D/DRC Case

1519 Sumter Street

DESIGN/DEVELOPMENT REVIEW COMMISSION
DESIGN REVIEW DISTRICT
HISTORIC AGENDA
EVALUATION SHEET
Case # 2

NATURE OF REQUEST: Request Certificate of Design Approval for Preliminary Certification for the Bailey Bill

1
A1.3 A1.5 ROOF PLAN
1/8" = 1'-0"

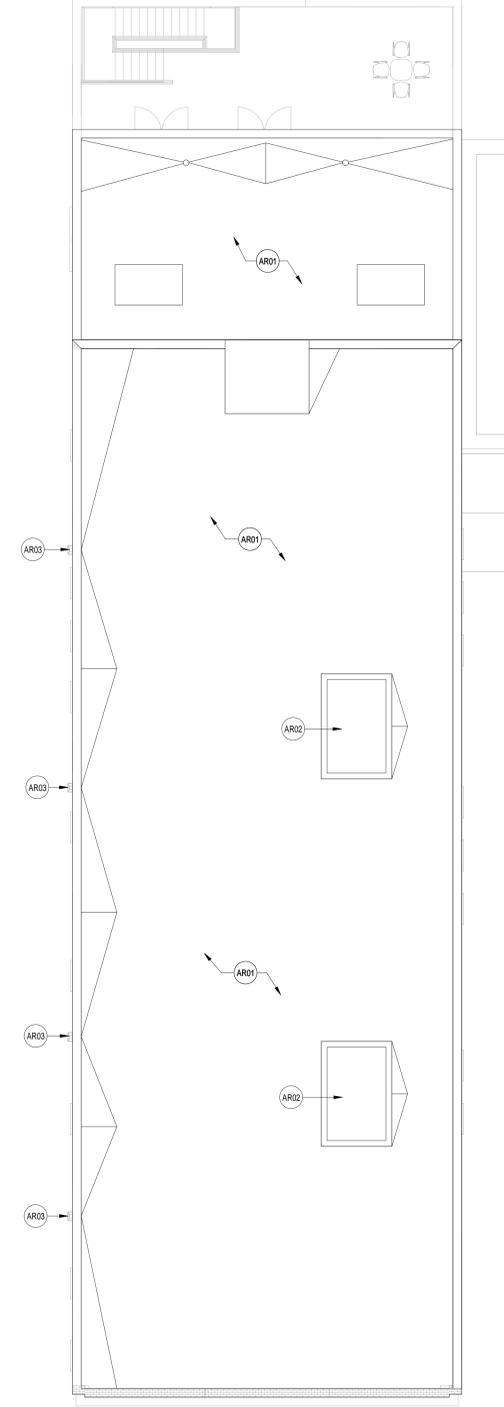
Roof: New skylights are proposed. These should be no more visible to the public right of way than the current skylights in order to stay in keeping with scale and massing of the building's current skylights.

- the project meeting or exceeding the 20% investment threshold requirements for qualified rehabilitation expenses
- All work meeting the standards for work as outlined in Section 17-698
- The storefront details match the historic appearance
- The storefront opening on the south elevation at the corner to be retained and treated as storefront
- The new windows on the north elevation to be distinguished as new openings, with details worked out with staff
- Windows to be changed to a 6/1 pattern, with exterior muntins and detailing matching historic windows
- No painted sign for Powell Furniture to be placed on the building
- New skylights should not be more visible to the public right of way
- All details deferred to staff

1 SOUTH ELEVATION
A4.1 3/16" = 1'-0"

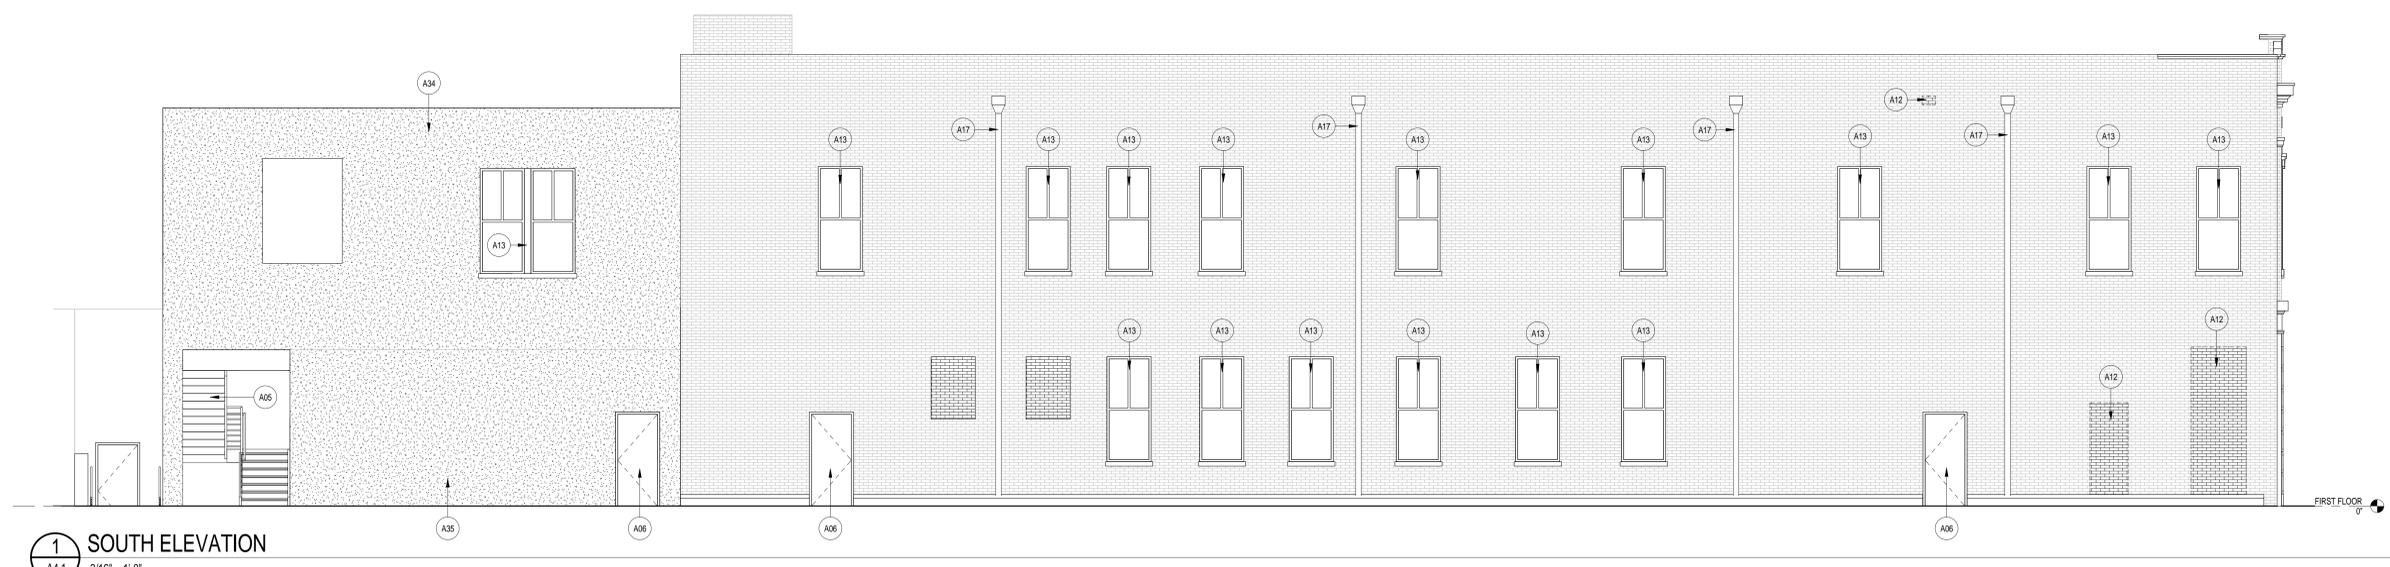
South Elevation: A majority of the historic window openings, which have been bricked in, will be reopened. The storefront of the building wraps to the south elevation for one bay, as indicated by the continuation of the textured cream brick (now painted). There is a storefront opening in the bay, closest to the façade, which still exists. The proposal is to brick up this opening. This would remove a historic feature and does not meet this ordinance.

The window and door openings that are new on the building should be distinguished from original openings so that they do not appear original. Surprisingly, a majority of the historic window openings on the south side do not feature a soldier brick course as a lintel and no evidence exists of the sill treatment. Staff can work on a design feature to make the new window openings distinctive.

If no historic windows are found in the original openings that have been bricked in, and which could be repaired (determination by staff), then new aluminum-clad windows are proposed. The proposed pattern of 2/1 is not consistent with the historic windows and does not meet this ordinance. A 6/1 pattern would be consistent.

South Elevation: There are a few exterior alterations proposed for this elevation, some are located near the rear in the concrete block addition and will not be highly visible to the public right of way. Closer to the front of the building a new door opening with a flat metal door is proposed. This will necessitate the loss of a minor amount of exterior brick; this brick should be salvaged for repairs to other parts of the building. The minor size of this pedestrian door is compatible with the building. A nearby pedestrian door that is closer to the façade will be bricked in; this is not an original opening and its infill will be an improvement for the historic appearance.

2 NORTH ELEVATION
A4.1 3/16" = 1'-0"

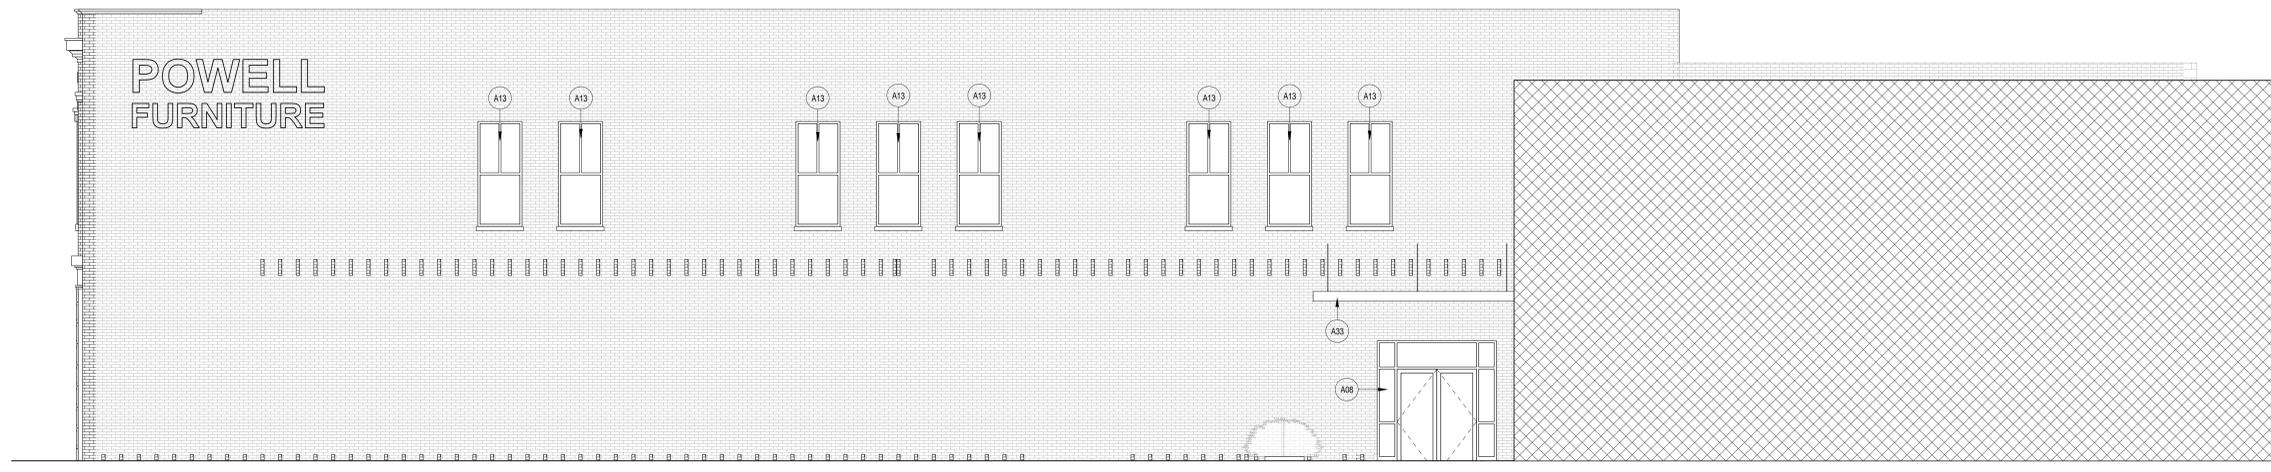
North Elevation: The historic character of this elevation is that it retained a long blank brick wall with very few openings. Perhaps the thought at the time of its construction was that a new commercial building would abut that side of the structure, but that did not occur. The proposal is to install eight new window openings and windows in the second floor and a new large doorway with sidelights in the far right bay of this elevation. While these new openings alter the integrity of the original design, they are somewhat minimal in proportion to the large wall and mimic some of the patterns found on the south elevation. This alteration would not infringe on any existing architectural features or rhythms of openings that characterize the property.

No changes on this building have acquired historic significance. The current “Powell Furniture” sign on the second story of the north elevation is not historic and is not consistent with the period the building is being returned to, which is from 1921. Powell Furniture was not in this building until 1960 and the current painted sign is not the sign on the building during the 1960s. As the new tenant is not going to be Powell Furniture this sign or name cannot be reattached or painted onto the building as proposed.

North elevation: The proposal is to install eight new window openings and windows in the second floor and a new large doorway with sidelights in the far right bay of this elevation. These new openings are fairly minimal and will remove some original historic material but a majority of the elevation will be kept intact. The window openings need some detailing so that they are clearly not seen as original openings; the doorway’s size and shape lends itself to that distinction. A metal canopy over the doorway is also proposed but would clearly be distinctive as a modern feature. These items are generally compatible with the other architectural features of the building.

Photo 11

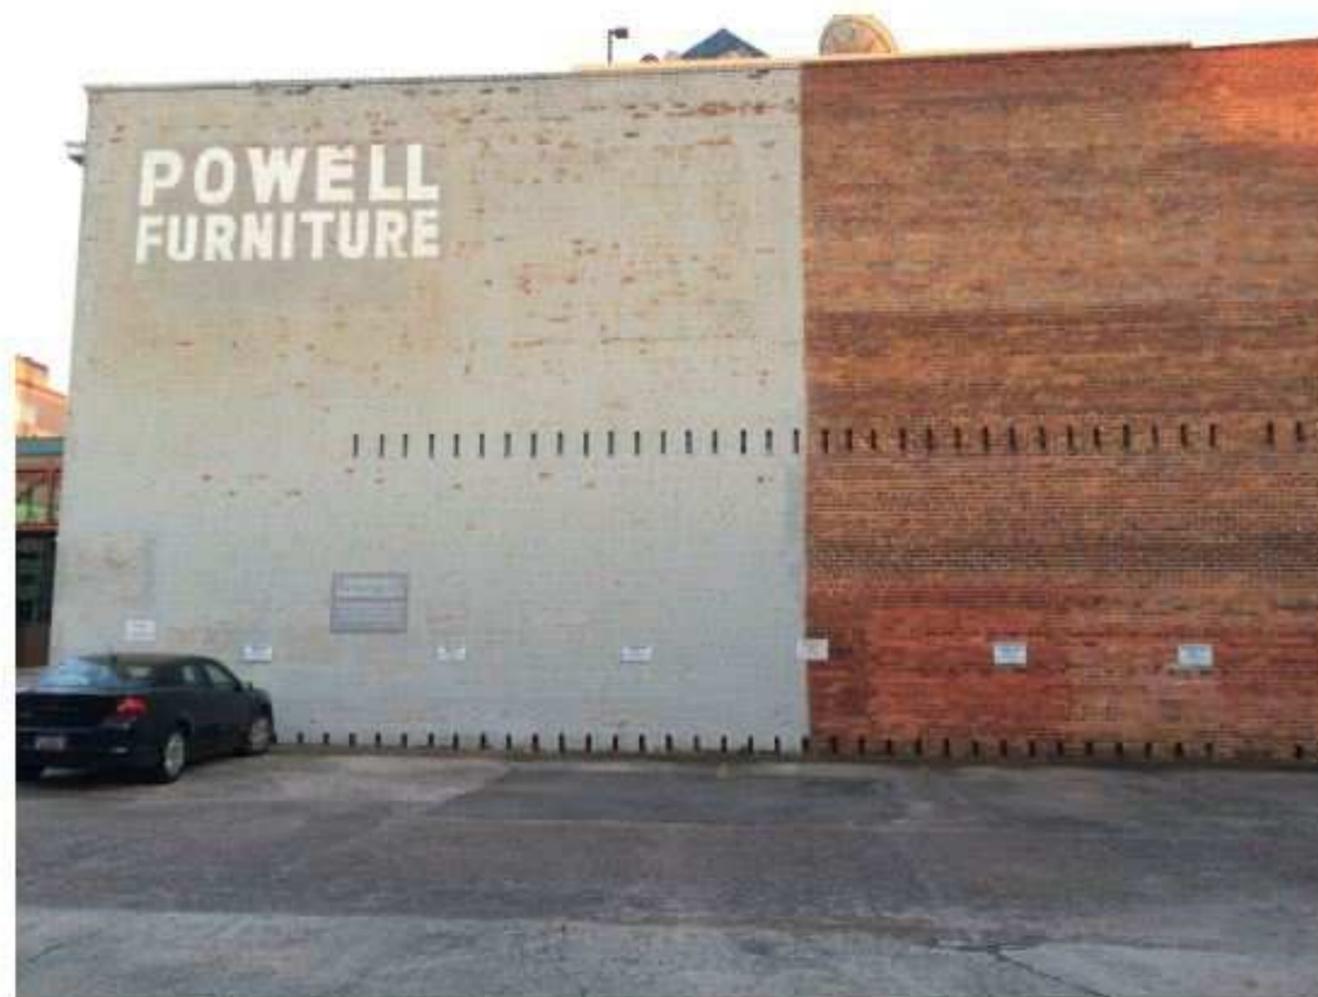
Photo numbers	8, 9	Drawing numbers	DA4.1, A4.1
Description of work and impact on feature			
Letters will be painted directly on the wall to spell "POWELL FURNITURE" in the same location as the earlier painted lettering.			
Feature number	8		
Architectural feature	Second level windows north elevation	Approximate date of feature	c. 1929
Description of existing feature and its condition			
The north elevation contains 8 uniform rectangular windows in its second level. The window in the easternmost bay contains a single soldier course lintel. All windows have been in-filled with masonry.			
Photo numbers	10, 11	Drawing numbers	DA4.1, A4.1
Description of work and impact on feature			
Existing masonry infill in all 8 of the second level windows will be sawn and removed to reopen existing windows. New aluminum clad double hung sash windows with pane configuration 2 over 1 will be installed in existing window openings. Magnetic sensors in these new windows will be wired to the building's security system. Replacement window style, material, profiles and details are to be historically appropriate subject to further research and staff approval.

Photo 12

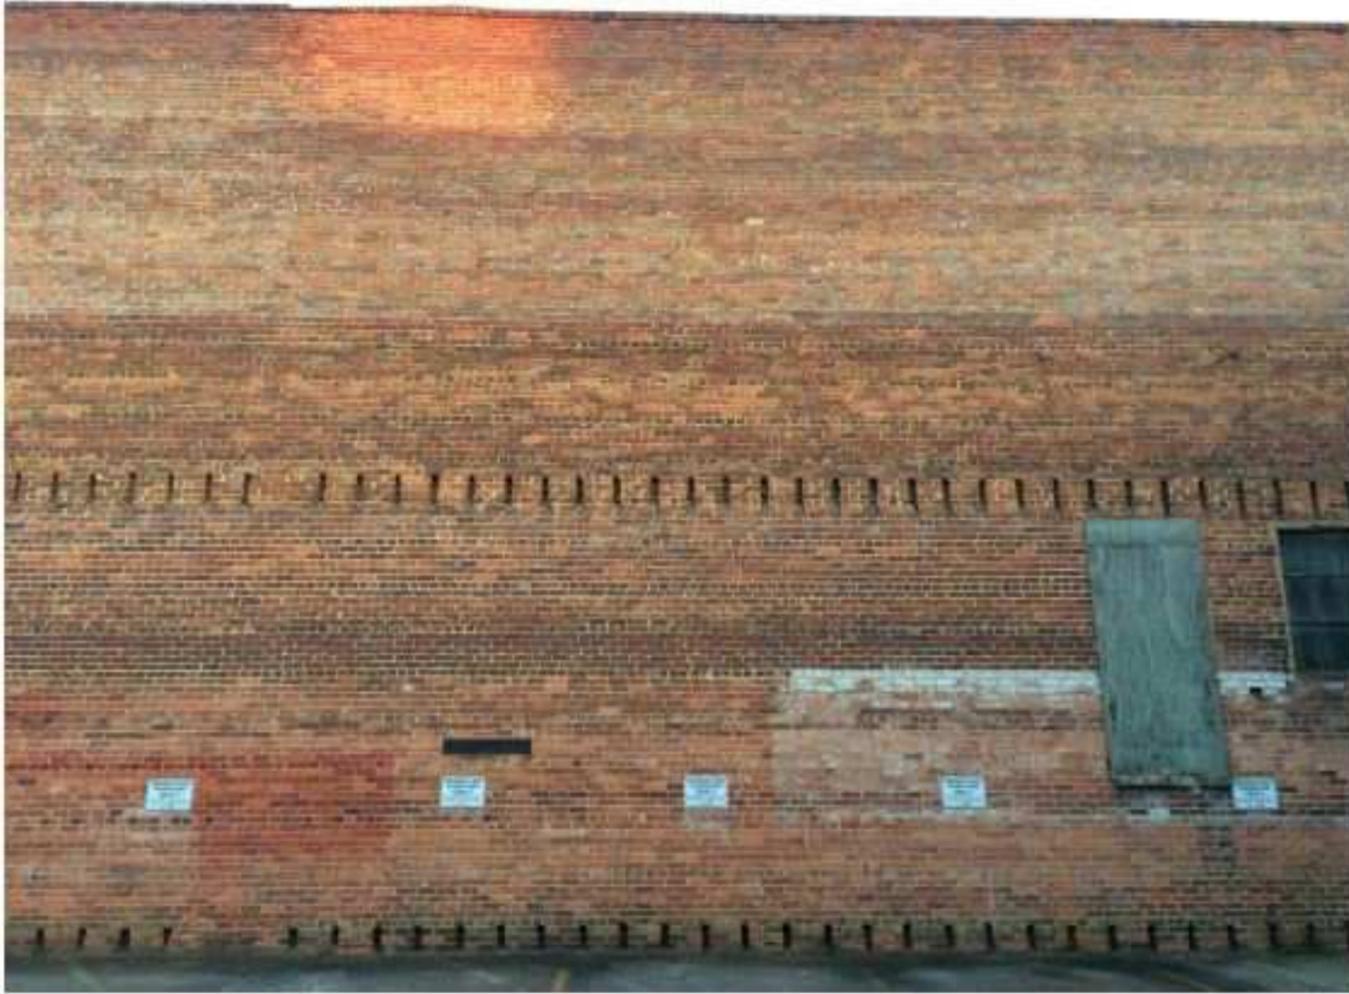
Photo numbers	12, 13	Drawing numbers	DA4.1, A4.1, A4.2
Description of work and impact on feature			
<p>Existing infill masonry will be sawn and removed to reopen earlier exterior doorway. New insulated, laminated, glass entrance storefront doors with side lights will be installed in this existing doorway. Access through these doors will be provided via card reader and door position switch. A new pre-engineered metal canopy system will be installed above this door. This metal canopy will be visible from the building's east elevation along Sumter Street.</p>			
Feature number	10		
Architectural feature	First level windows south elevation	Approximate date of feature	c. 1929
Description of existing feature and its condition			
<p>The first level of the south elevation contains 10 windows, including 1 storefront window in the southeast corner that is visually similar to the storefront windows in the first level of the building's east elevation. This storefront window has a single soldier course lintel. The two westernmost windows are shorter than the rest. All windows (except the singular storefront window in the southeast corner) have been infilled with brick. None are presently serving as openings to the building.</p>
